BERKSHIRE E-SUPPLY JSP17-72

Public hearing at the request of Berkshire E-Supply for Preliminary Site Plan with land bank parking, Wetland Permit, Woodland Permit, and Storm water Management plan approval. The subject property is approximately 57.12 acres and is located at the southeast corner of M-5 and W Fourteen Mile Road (Section 1). The applicant is proposing a two-story headquarters office building (18,380 SF) and a single story Fulfillment Center and warehouse with mezzanines (193,230 SF) with associated site improvements such as parking, loading and landscaping. The proposed site plan also proposes to land bank up to 74 parking spaces of the 359 required spaces.

PLANNING REVIEW

Revised Preliminary Site Plan

PRELIMINARY OVERALL SITE PLAN A PC-03

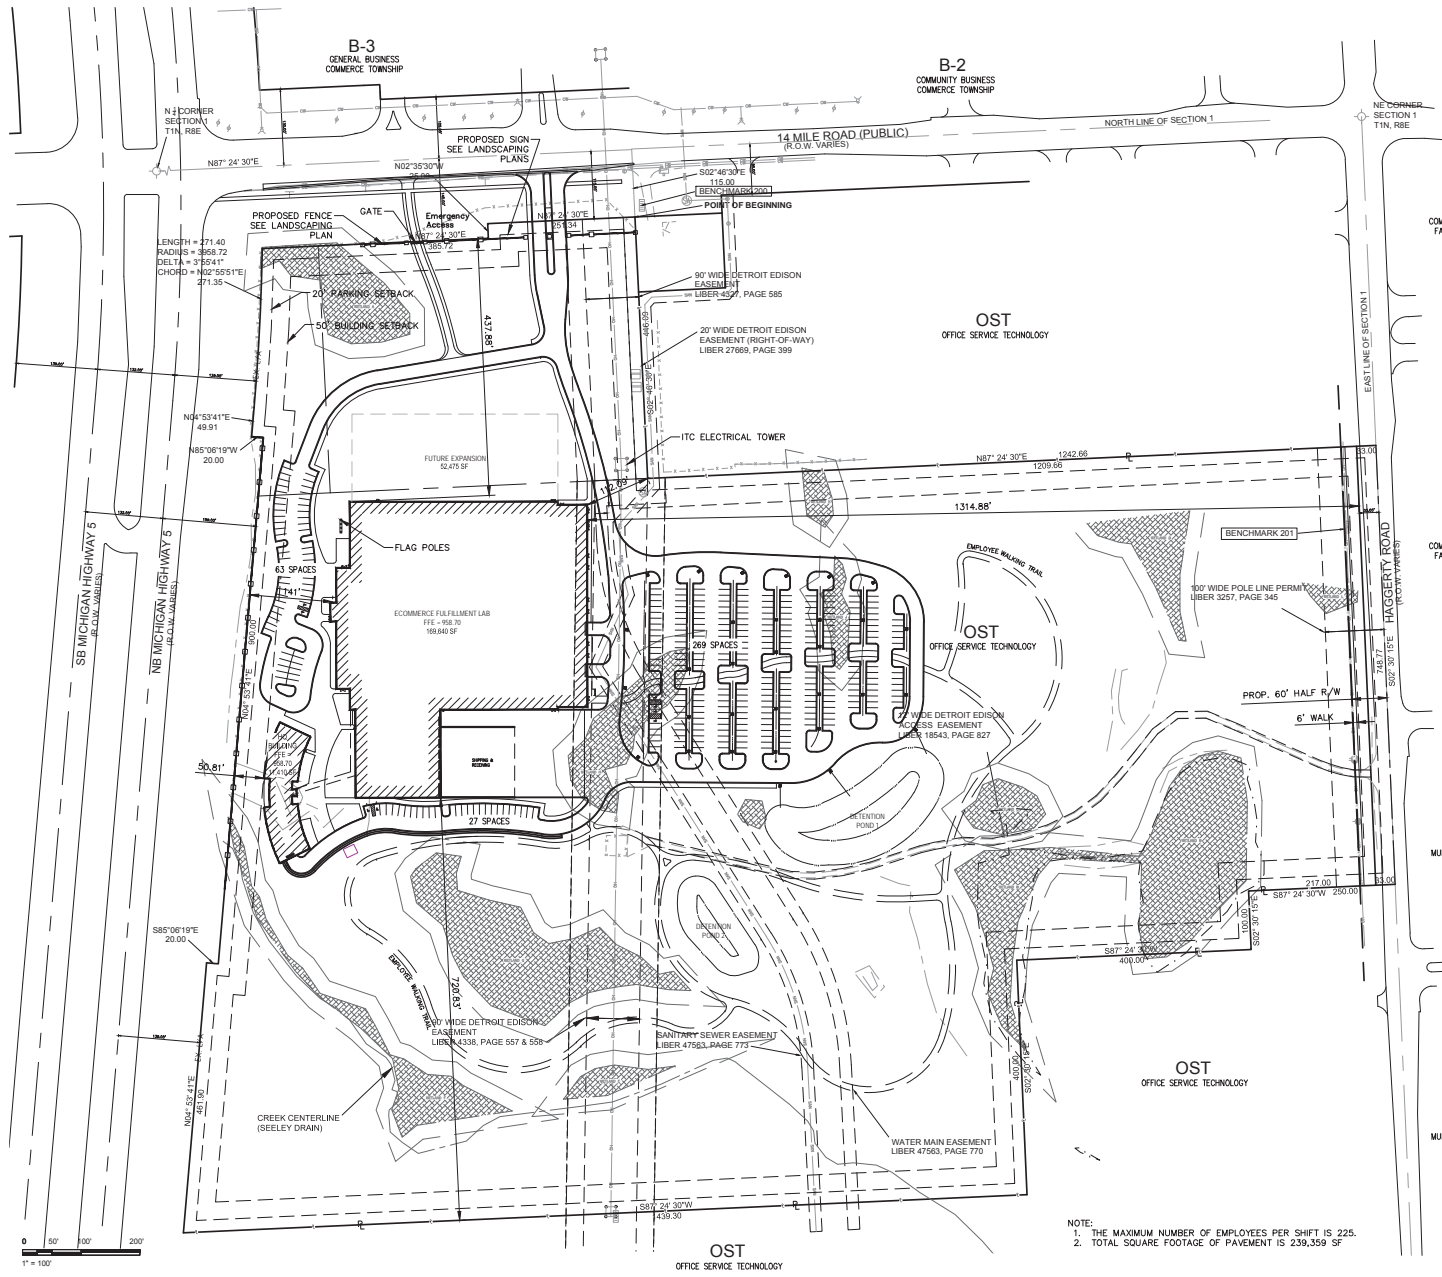
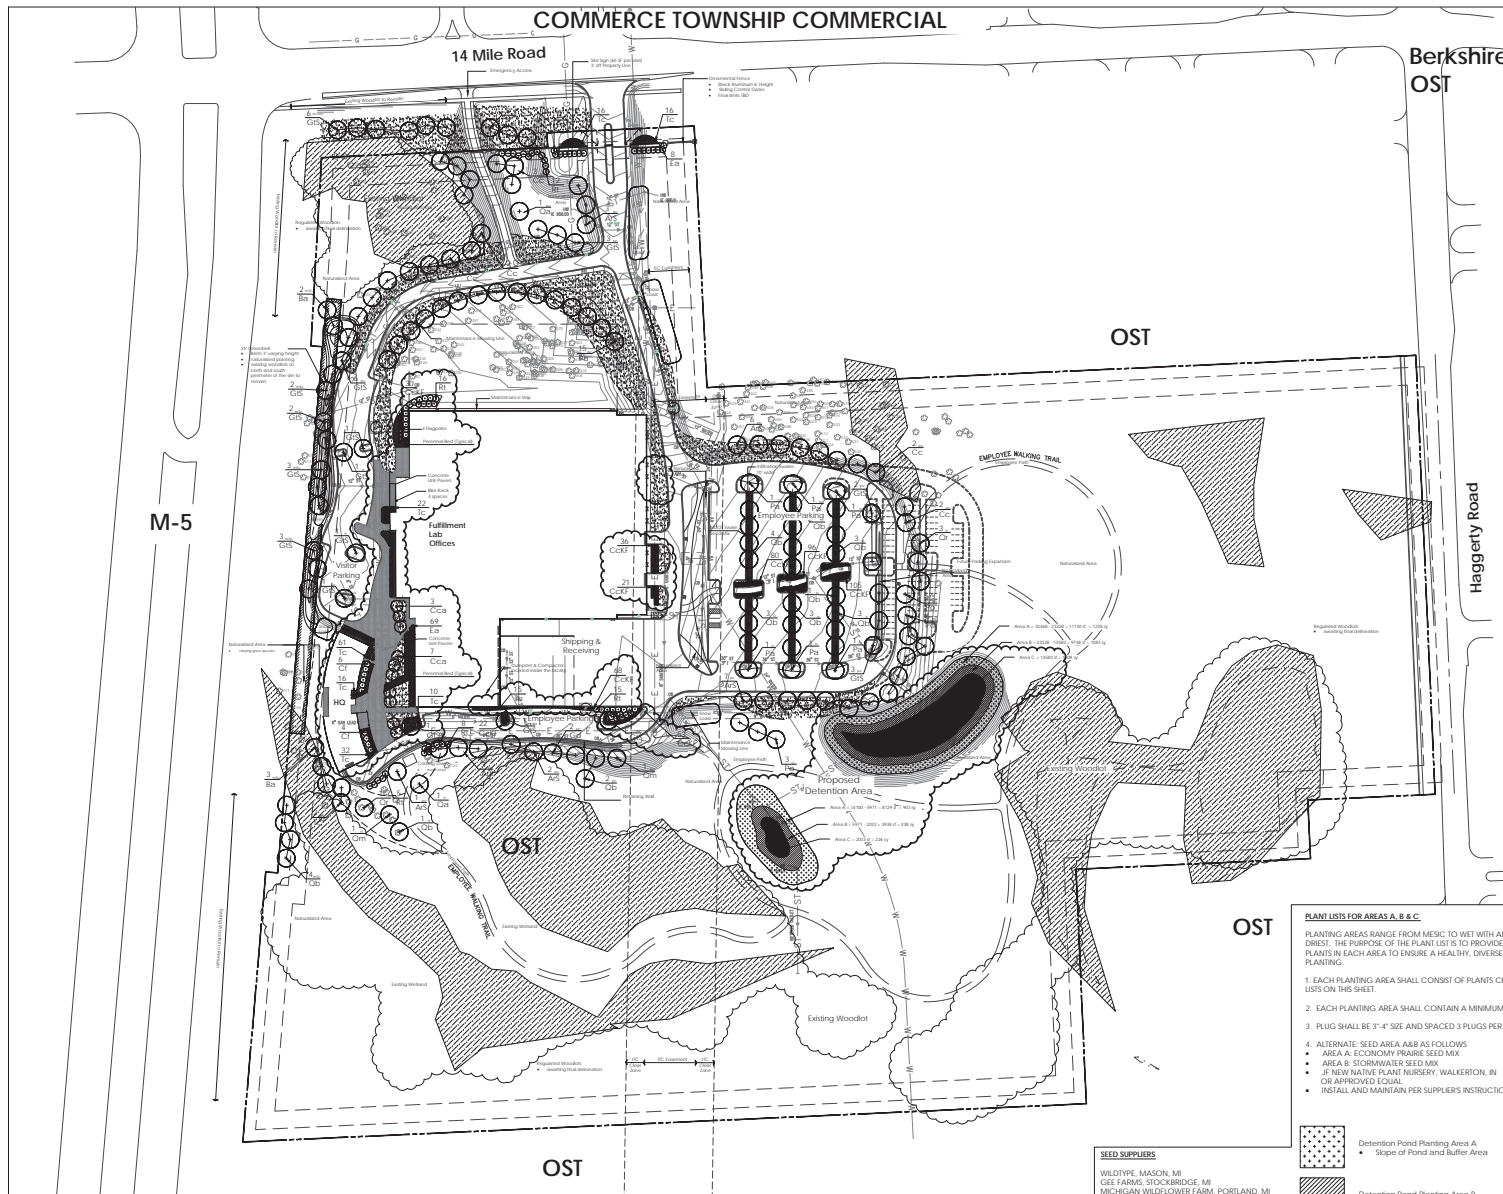
REVIEW	RESULT	DATE	COMMENTS
Planning	Approval recommended	02-23-18	<ul style="list-style-type: none"> • Applicant to update the entry way design and signal location as shown in the updated 'PC-04: Preliminary Site Plan' PDF provided with the response letter dated February 23, 2018 • Approval of up to 74 land bank parking spaces (Total 359 required) • Zoning Board of Appeals variance for location of loading area in the side yard and for additional flag pole (4 proposed, 3 permitted); Approved February 13, 2018 • Items to be addressed by the applicant with the revised submittal
Engineering	Approval recommended	02-14-18	<ul style="list-style-type: none"> • City Council approval of agreement to pursue water service from another community • Items to be addressed by the applicant prior to Final Site Plan approval
Landscaping	Approval WITH CONDITIONS recommended	01-29-18	<ul style="list-style-type: none"> • Waiver for reduction of required street trees and berm along Fourteen Mile Road • Waiver for reduction of minimum required parking lot perimeter and parking lot interior trees • Waiver for reduction of required greenbelt trees along M-5 corridor • Items to be addressed by the applicant prior to Final Site Plan approval

- n. The applicant shall install the Traffic signal at the entrance along Fourteen Mile Road as shown in the updated 'PC-04: Preliminary Site Plan' PDF provided with response letter dated February 23, 2018, and as shall be provided in more detail on the Final Site Plan submittal, prior to the Temporary Certificate of Occupancy;

- o. The applicant shall provide correspondence from the Road Commission for Oakland County (RCOC) to the City prior to Final Site Plan approval in regard to the future considerations for any future 14 Mile Road improvements, such as widening, RCOC's approval of proposed traffic signal location, right turn taper/lane, and entry driveway design (as shown in the updated 'PC-04: Preliminary Site Plan' PDF provided with response letter dated February 23, 2018);
